Product hierarchy no. *				Part no.	SBU	Type / Description	Customer part no.
SBU	PG	PGU	Type				
01	001	025	0000000205	See list below	Circuit Protection	USF 1206	n/a

Product Change Notification					PCN_USF 1206 0.750 A		
owner	creation date	release date	released by	change order no	rev	page	D10-006-945
ganderka	2016-07-26	2016-08-09	bergerra	2010595	A	1 of 2

Current marking	New marking

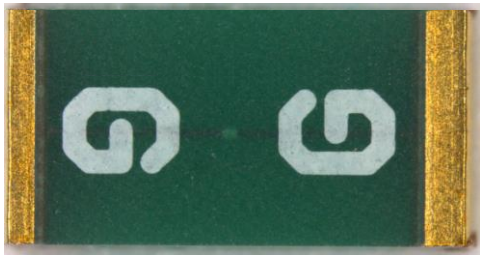
- Improved marking readability
- Change of body material

Letters do not change

- Symmetric marking to provide marking readability independent from device placement in blister.
- Necessary change of body material due to material phase out.

Form	Yes	New body material and marking adjusted
Fit	No	There are no dimensional changes.
Function	No	This is a non-functional change
Production Site	No	There is no change of the production site.
Product Label	No	No label change
Customer Action	No	Notification only
